42 Bedford Square

Design & Access Statement
Addendum 2
April 2022

42 BEDFORD SQUARE

DAS ADDENDUM 2

LOWER GROUND FLOOR PLAN - CONSENTED

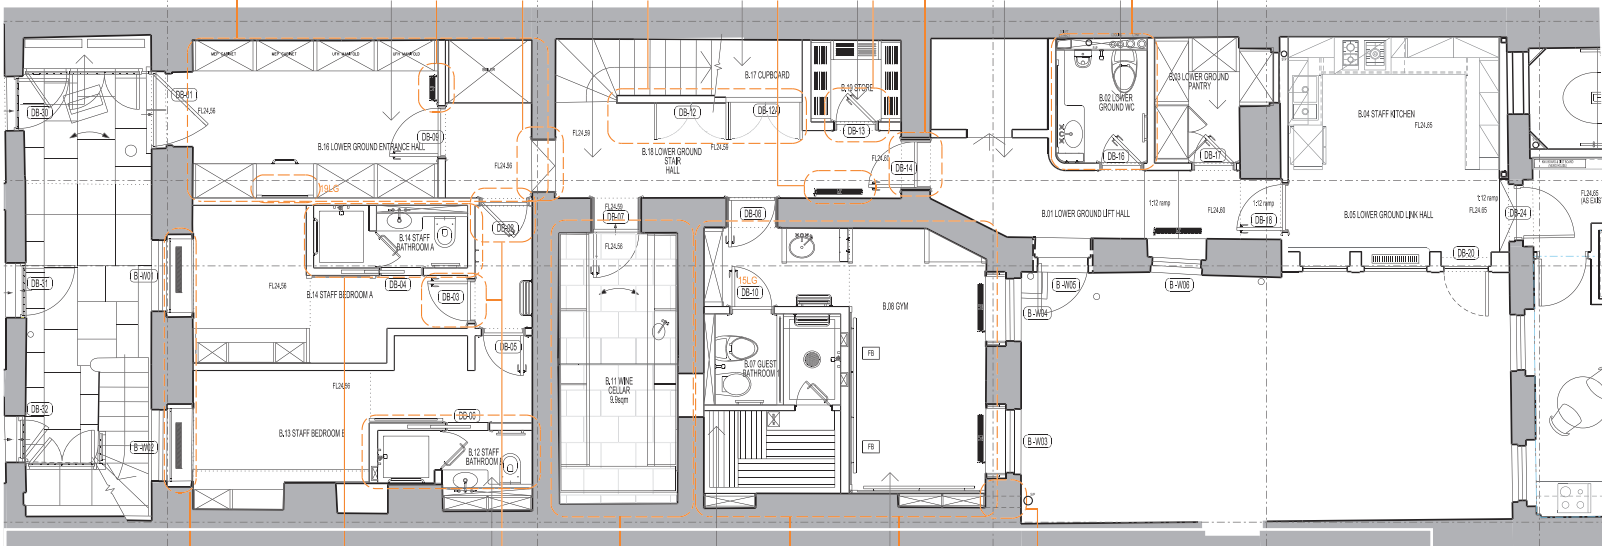
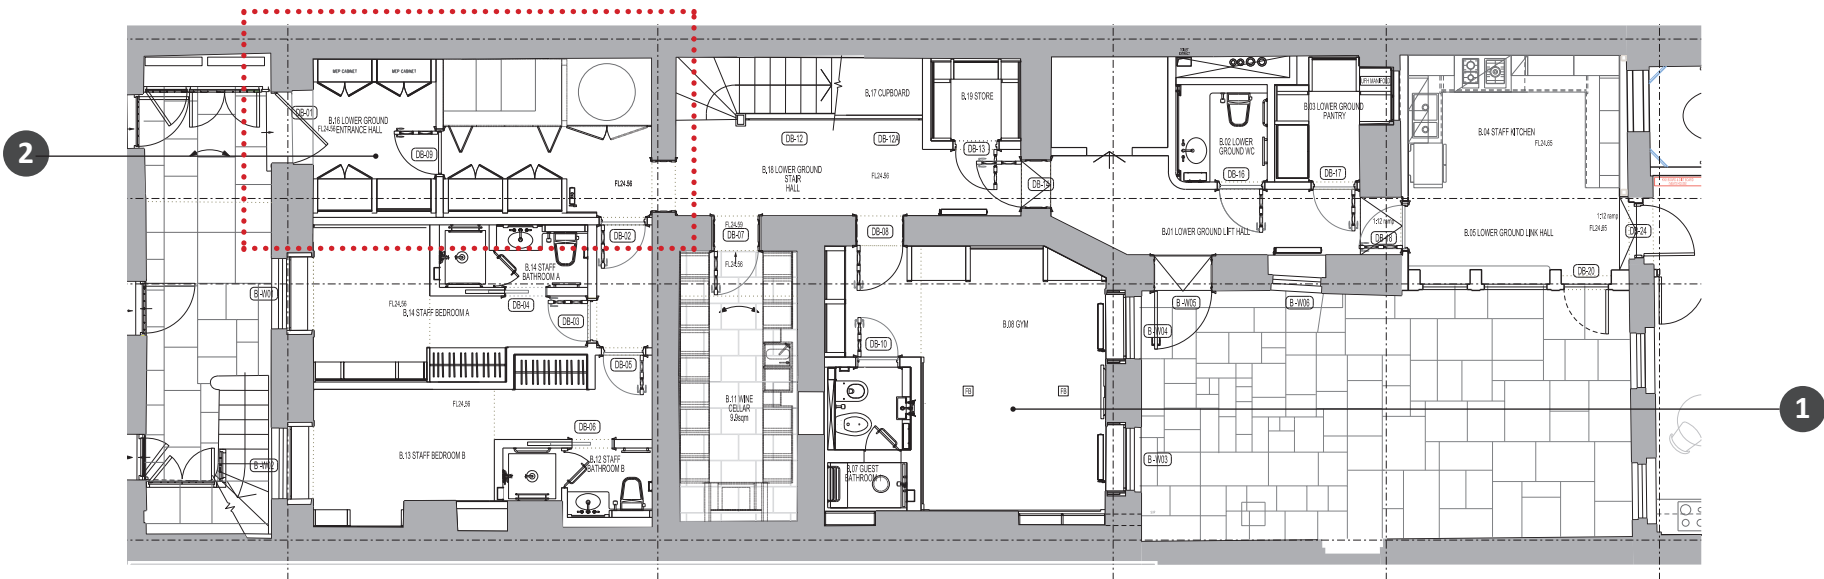
- Sauna within Gym removed & shower/WC reconfigured
- Layout change to Entrance Hall area

Sauna omitted
Sauna to Gym room to be omitted. A shower room is proposed instead. The overall footprint of the WC & shower will be smaller, reducing the impact to the main room volume. This item was reviewed in a pre-application workshop held on 27th October 2021 with the Conservation Officer and was welcomed as a positive change.

Entrance Hall
The layout to Entrance Hall has been revised to accommodate changes to the building services plant. The fitted cupboards and partition to the Entrance Hall have been rearranged in order to provide space for the back-up battery power supply to the lift. This battery power supply (UPS) is required in order to keep the lift functioning as an escape route in the event of an emergency. This item was reviewed in a pre-application workshop held on 16th March 2022 with the Conservation Officer and was acceptable in principle.

- 1 Sauna omitted
- 2 Entrance hall arrangement revised

FIRST FLOOR PLAN - CONSENTED

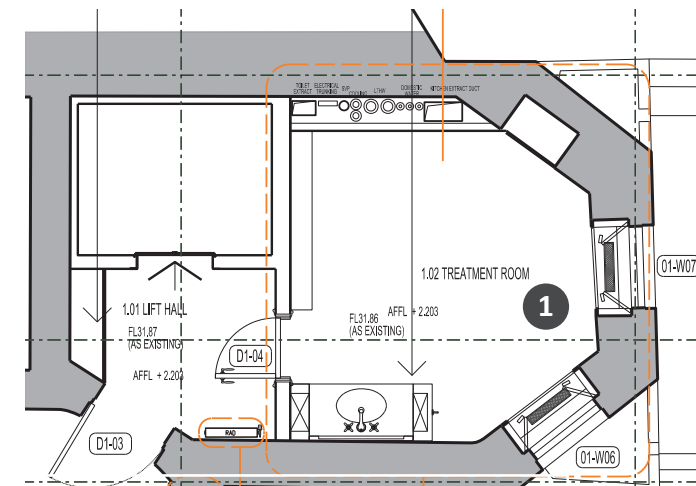
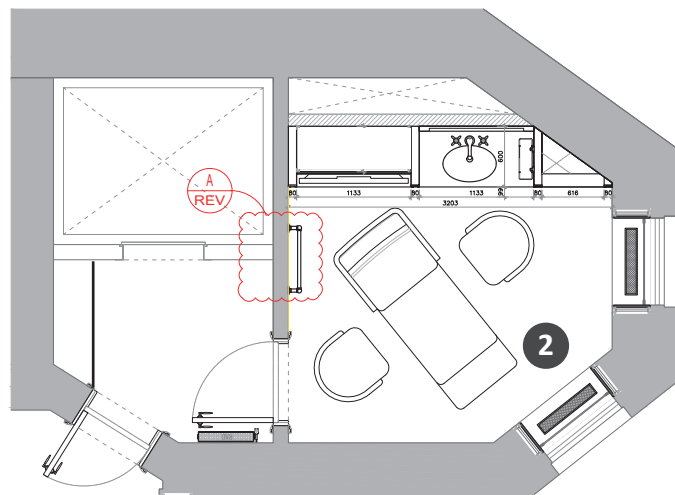
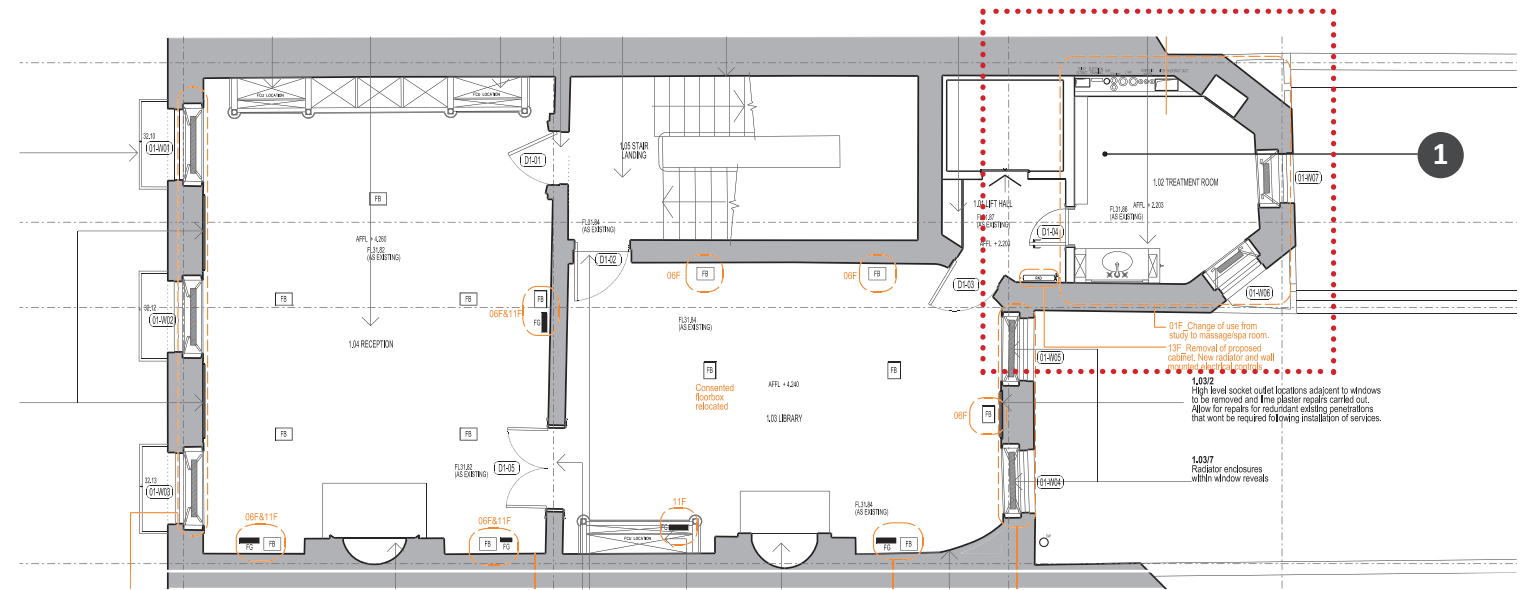
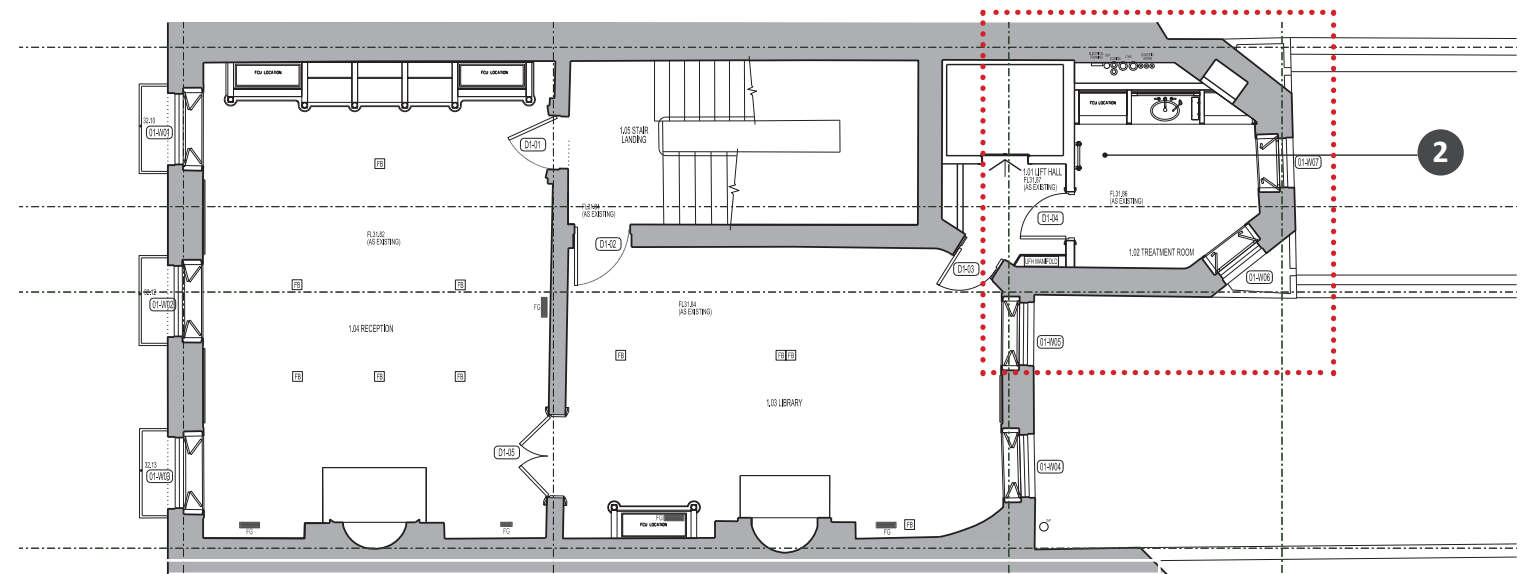
Reduction and repositioning of the wash basin vanity unit and relocation of the towel rail.

This item was reviewed in a pre-application workshop of 13th July 2021 with the Conservation Officer and was acceptable in principle.

- 1 Treatment/Spa room as consented
- 2 Treatment/Spa room as proposed

GROUND FLOOR PLAN - CONSENTED

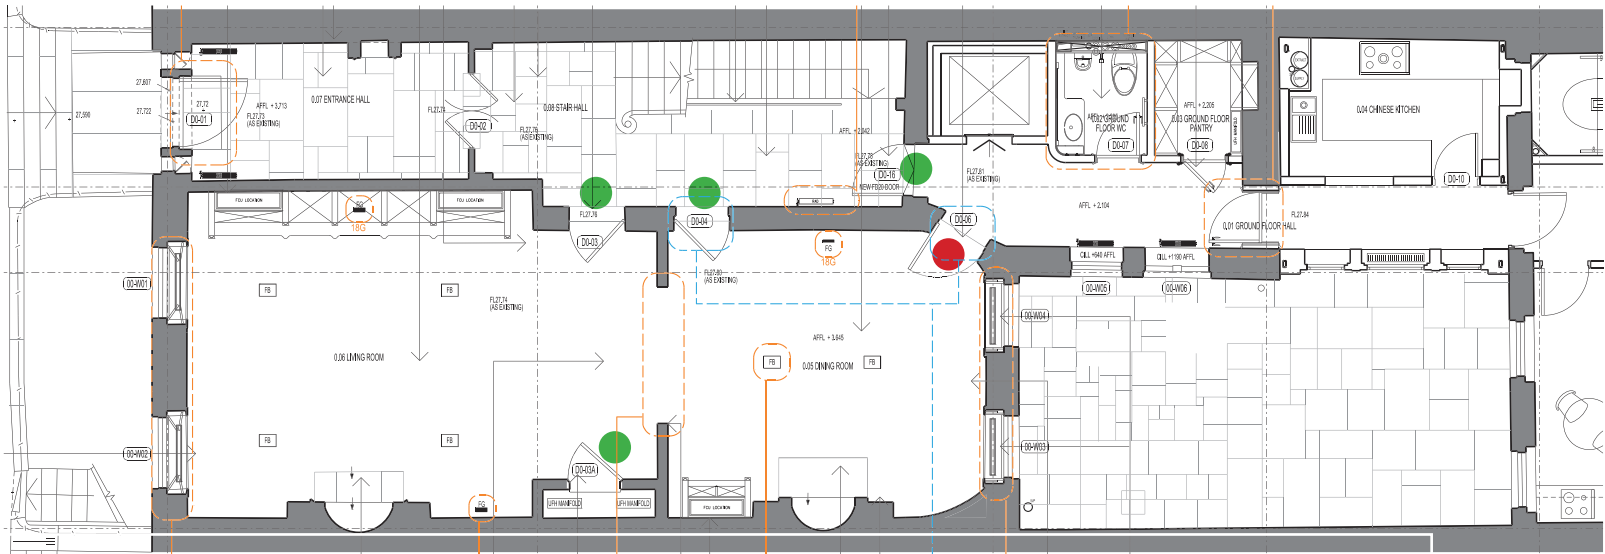
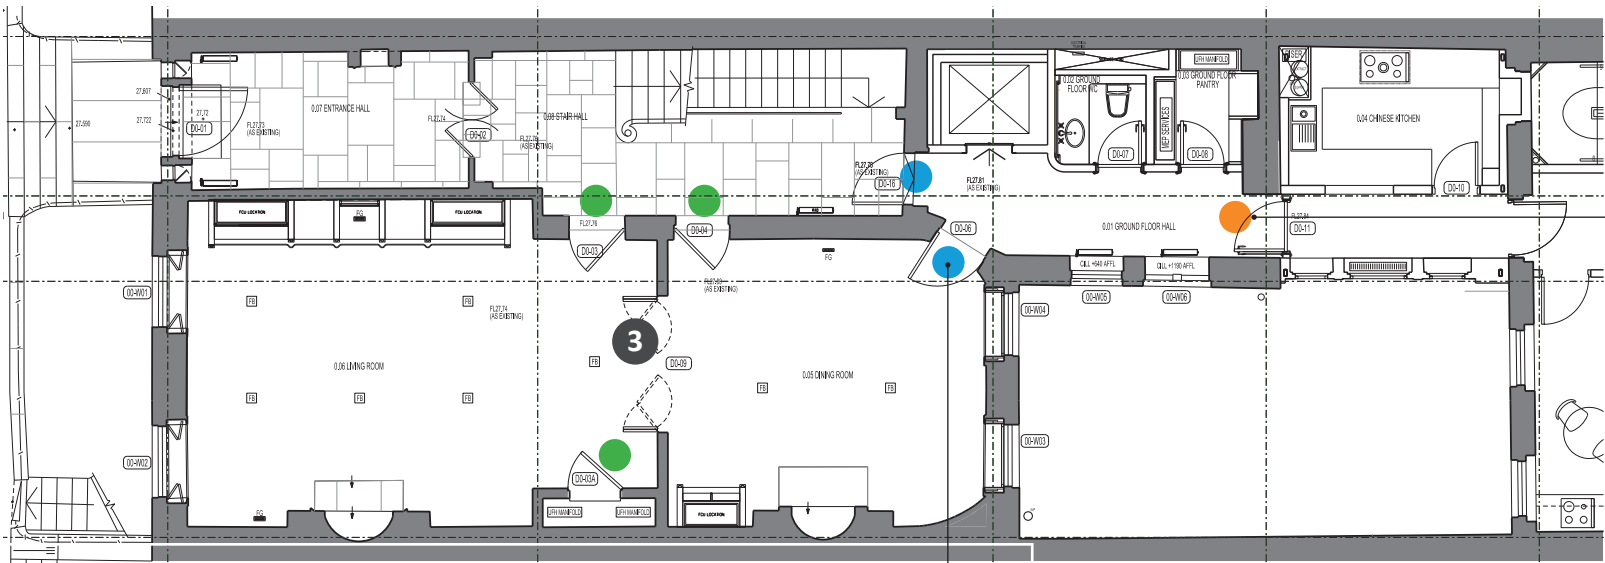
- Relocation of existing historic mahogany door (D0-16) at Ground Floor
- Replacement of missing door (D0-06)
- Reintroduction of bi-folding doors between Ground Floor rooms (D0-09)

The fire strategy requires door D0-16 to be a fire door that can resist fire and smoke for 30 minutes (FD30S). The location of this door is critical as it separates both the main escape route (via the main stair) and the secondary escape route (via the lift and lift hall). The fire performance is required to prevent both escape routes from becoming compromised at the same time.

An option to retain the door in place and apply fire rated finishes has been explored and discounted as not viable as the existing door is too thin to provide an adequate base (32mm, with raised and fielded panels of 4-5mm).

The installation of sprinklers in lieu of a second means of escape has been discounted as too invasive to the heritage fabric of the house and in particular the fine Stair Hall. the addition of a fire curtain or a fire door directly behind have also been discounted because of spatial constraints and impact upon the setting.

A number of options to relocate the door have been explored, including locations at Lower Ground Floor. The preferred option is to retain the door at Ground Floor to the location of D0-11 in between the Lift Hall and the Chinese Kitchen. A facsimile door (fire door) that matches the existing doors D0-03 & D0-04 in style and finish is proposed.

This item has been reviewed during several pre-application workshops during 2021 & 2022 with the Conservation Officer. Relocation of D0-16 to position of D0-11 was agreed as the best compromise solution during the workshop of 16.03.22.

| ● Existing panelled door | 1 D0-16 relocated to main house Lift Hall (D0-11) & replaced with facsimile fire door |
| ● Missing door | 2 D0-06 missing door replaced with facsimile fire door |
| ● Facsimile panelled door (fire door) | 3 D0-09 bi-folding doors between rooms (as 2017 consented proposals) |

Replacement of missing door

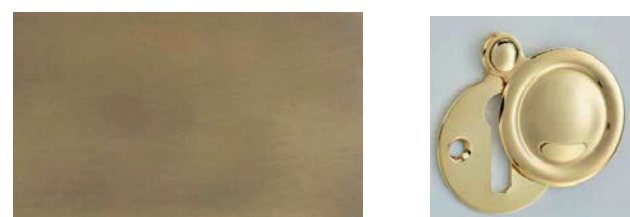
Door D0-06, rear Dining Room door is not on site. A facsimile door (fire door) that matches the existing doors D0-03 & D0-04 in style and finish is proposed. This item has been reviewed during several pre-application workshops during 2021 & 2022 with the Conservation Officer and accepted as the best solution during the workshop of 16.03.22.

SECTION I - I CONSENTED

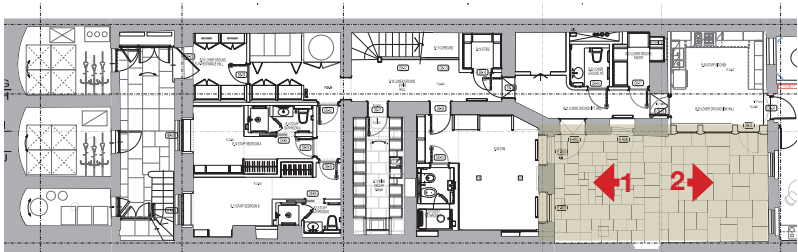
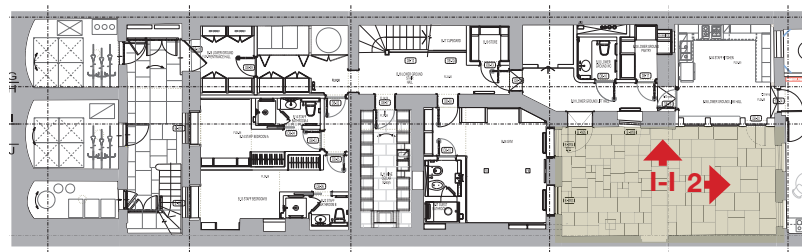
An area of planted vertical green wall is proposed to the western wall of the courtyard. The living wall is comprised of a proprietary vertical planted system that is to be maintained and irrigated. it will be supported by a rail system, requiring a limited number of fixings. The living wall will provide pleasant greenery to the Courtyard external space and will also have acoustic and C02 reductive properties.

6 external wall lights are proposed. lights will be wall mounted and fed from within. No surface mounted cables or conduits are proposed. The proposed light fitting shall be brass or bronze with a glass shade.

A number of external sockets are proposed at low level. No surface mounted cables or conduits are proposed. These items were reviewed in a pre-application workshop of 16th March 2022 with the Conservation Officer and were acceptable.

- 1 External lighting to walls
- 2 Power outlets
- 3 Living wall

SECTION J - J CONSENTED

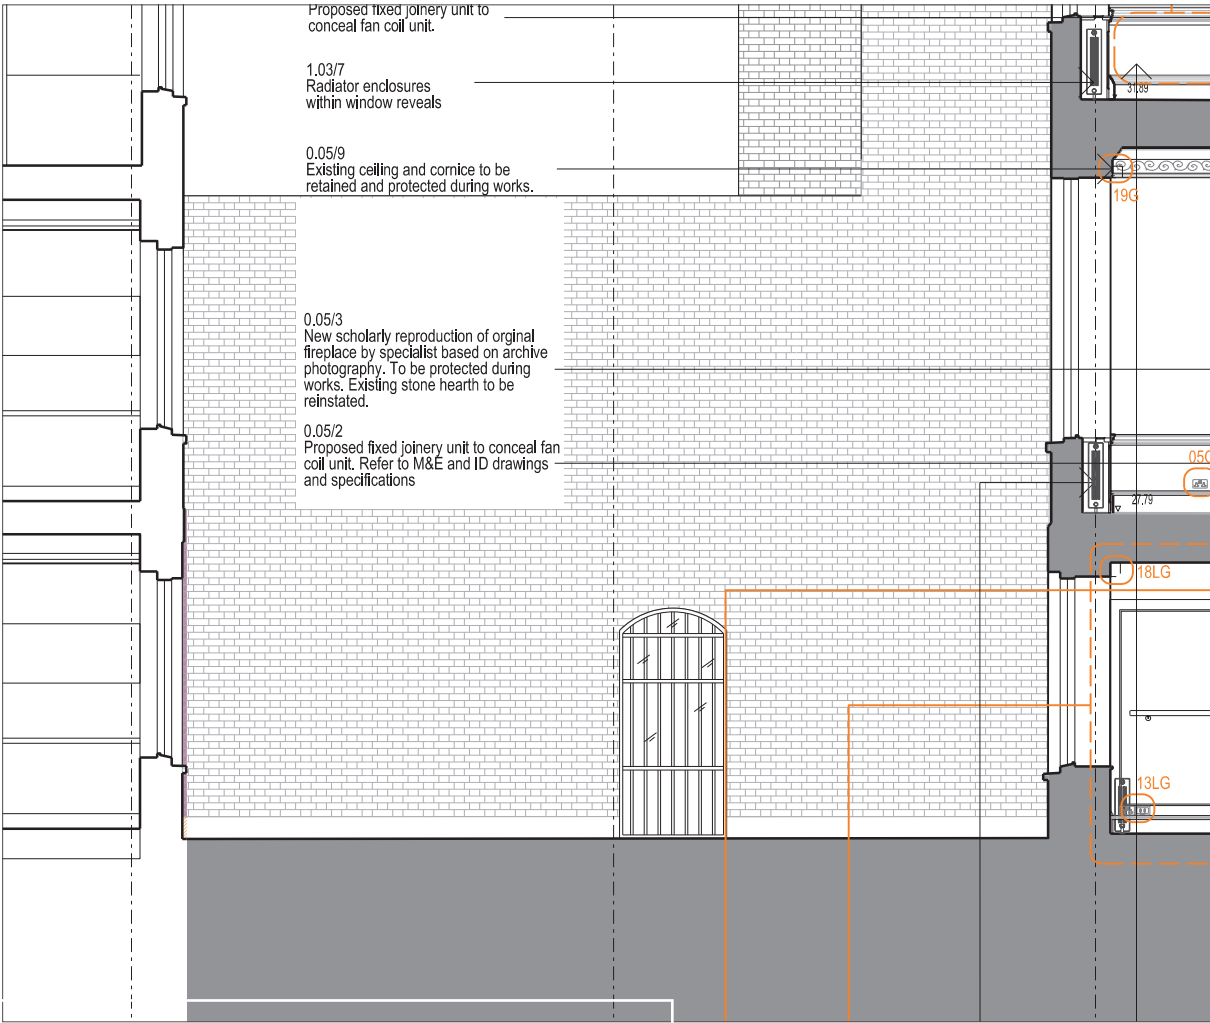
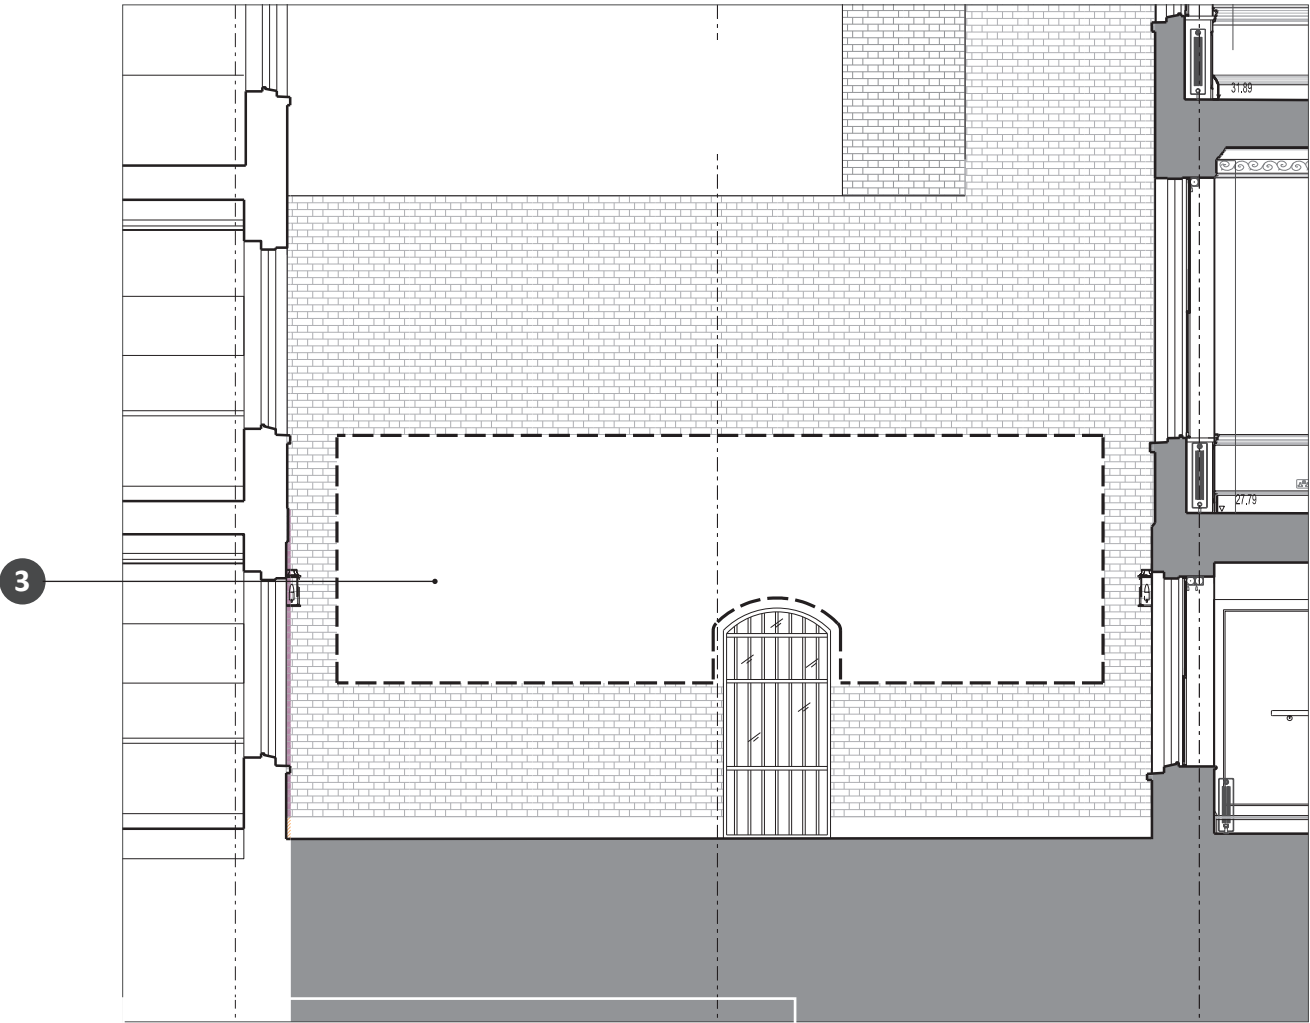
- 1 External lighting to walls
- 2 Power outlets
- 3 Living wall

SECTION 0 - 0 CONSENTED

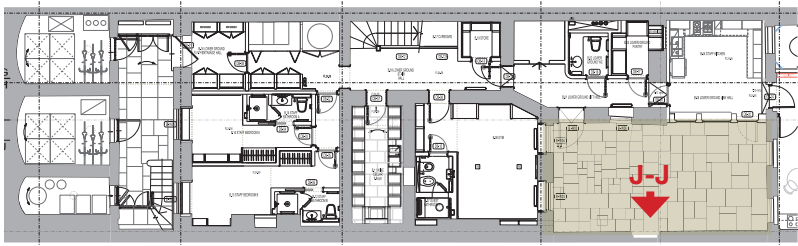
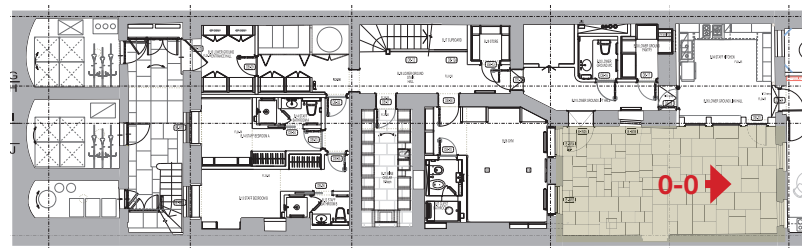
- ① External lighting to walls
- ② Power outlets
- ③ Living wall
